La Vergne Planning Commission
March 31, 2026 at 6:00 PM

Item #: 3. **Site Plan - 1370 Heil Quaker Boulevard - Proposed Truck Parking on 2.51 Acres. Property located at 1370 Heil Quaker Blvd. (Tax Map 17, Parcel 28.01). ID (Interchange District) Zoning District. Property owned by Harsimranjeet Kaur. Requested by Huddleston Steele, Inc. (DEFERRED)**

Reviewed By:
Bo Logan, City Planner
Gary Lide, City Engineer

SITE LAYOUT PLAN

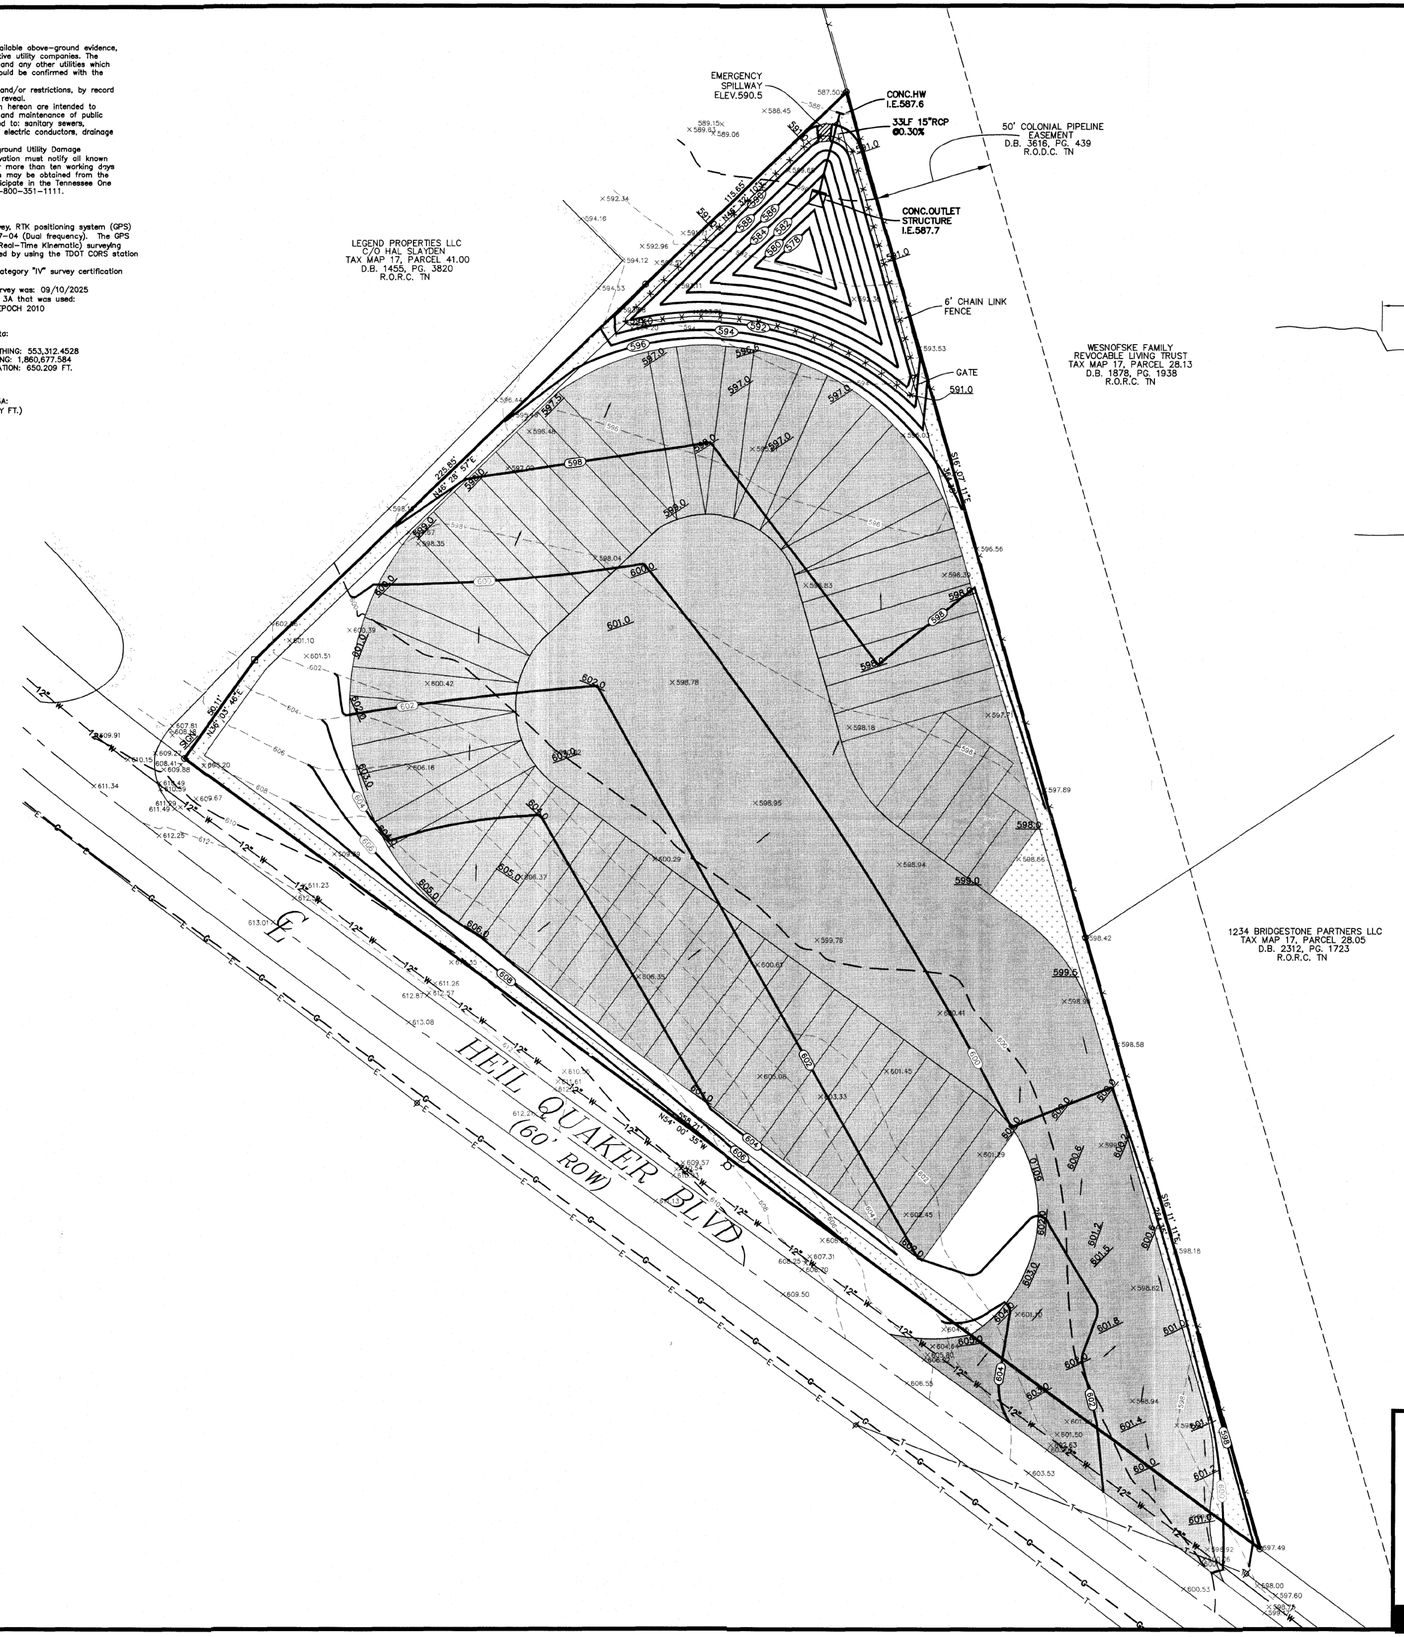
E. (Sheet 2 of 5) A 125-foor wide driveway ramp appears excessive. 48-foot striped with four 12-foot lanes would seem more reasonable for this use. If turning radii are a concern, then islands or some form of channelization to make this entrance less confusing should be added.

J. (Sheet 2 of 5) Please define and label the groundcover for the areas are that are neither described as "Asphalt Pavement" or "Landscape Area".
K. (Sheet 3.1 of 5) Show EPSC details.

L. (Sheet 2 of 5) Provide a five-foot wide public sidewalk along the road frontage of Heil Quaker Blvd.

EROSION CONTROL PLAN

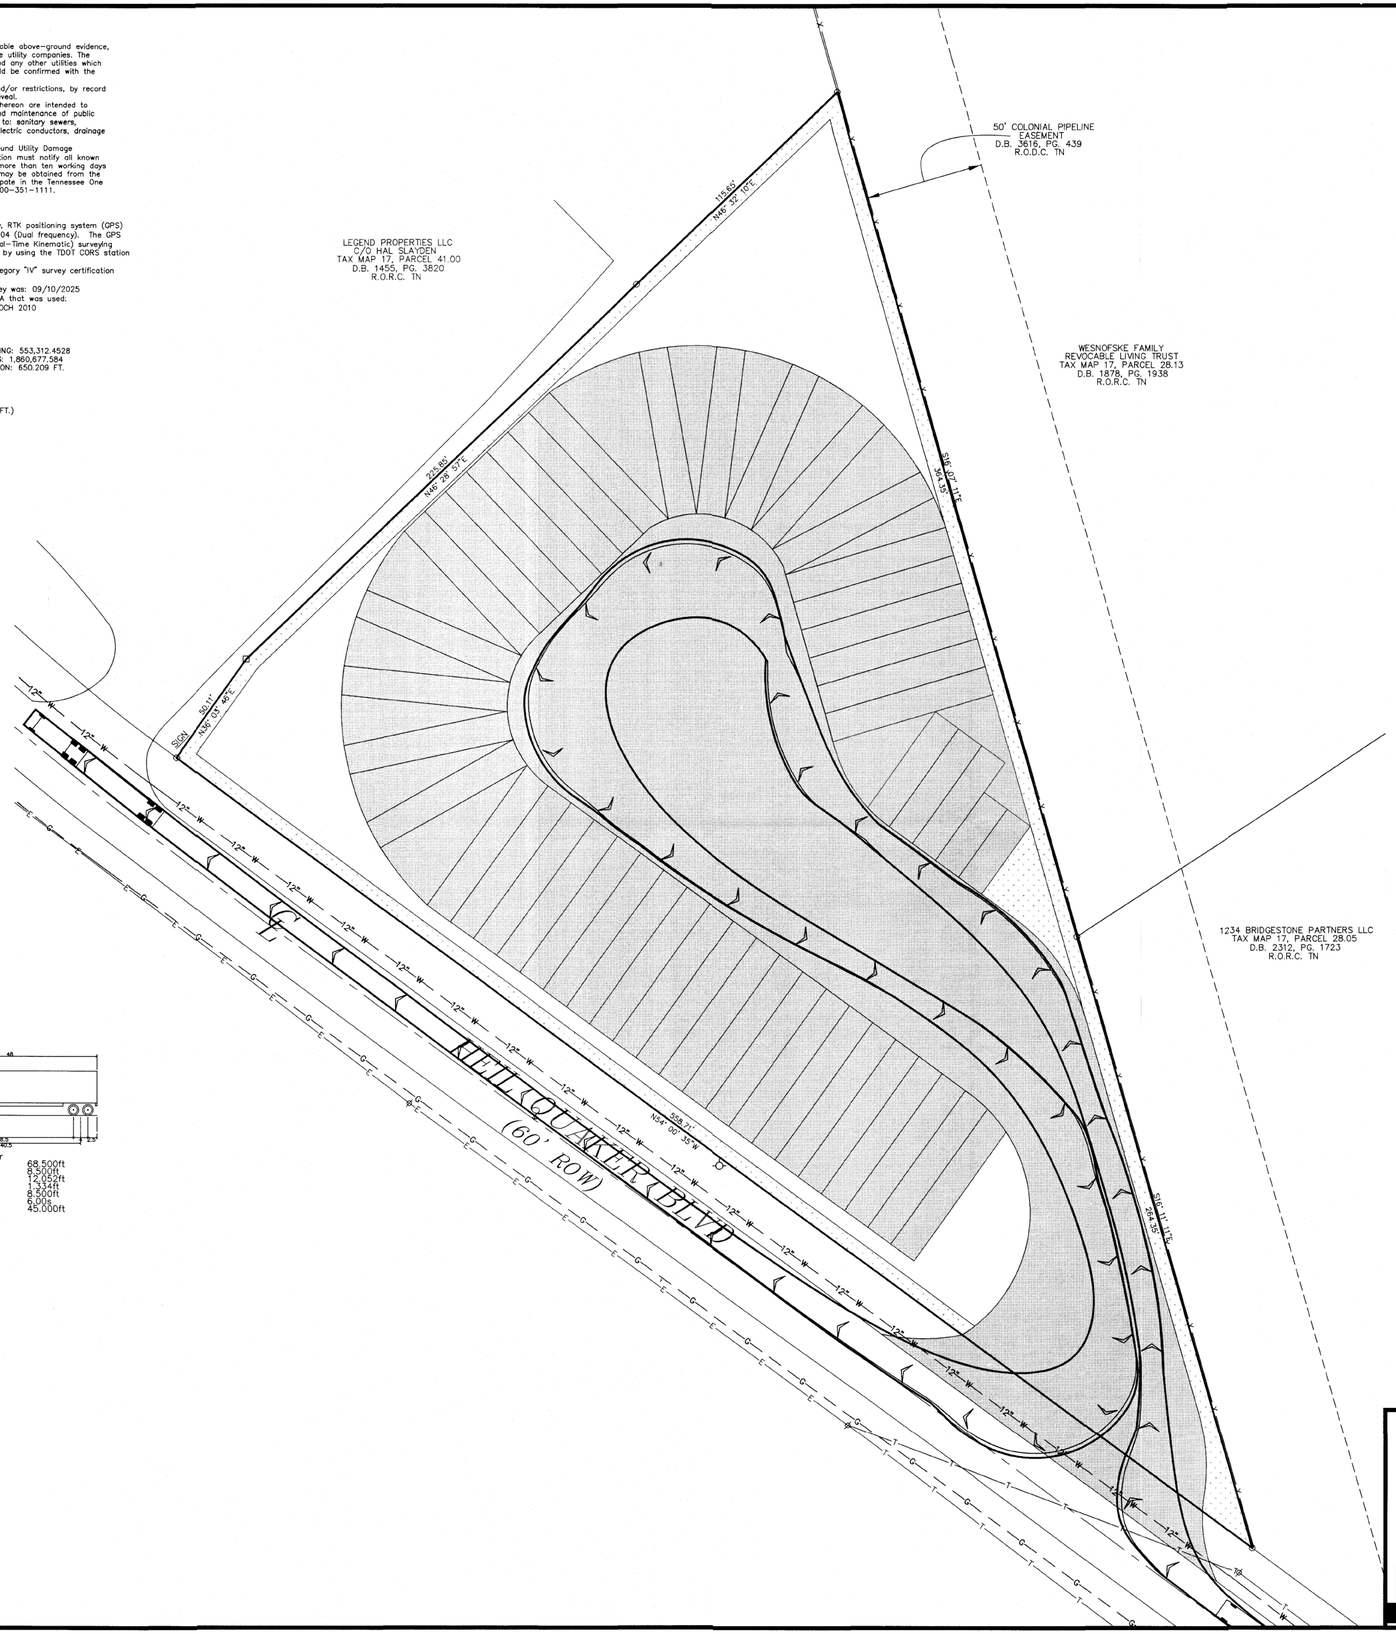
B. Provide a traffic study showing the impact of the truck traffic on Heil Quaker Boulevard during the AM and PM peaks.
C. (Sheet 3 of 5) In the existing condition, this site sheet flows to the east into the Colonial Pipeline Easement. The present plan calls for the runoff to be concentrated and released at a single point at the northern tip of the site. There is no ditch at that location. A standard energy dissipator at the end of the pipe will not change this from a concentrated flow. Some form of spreader which spread the flow out so that it leaves the site more as sheet flow will be required. Stormwater detention will be required in addition to this.

F. Provide pavement section for asphalt pavement.
G. (Sheet 3 of 5) More detail is needed to prove that the entire paved area will flow into the detention pond as shown in the calculations.

H. (Sheet 3 of 5) The runoff from the paved area is shown to flow directly from the asphalt to unpaved area and then immediately down a 2:1 slope. This entire area (Including the 2:1 slope to the bottom) will need significant protection. Riprap is considered a minimum.
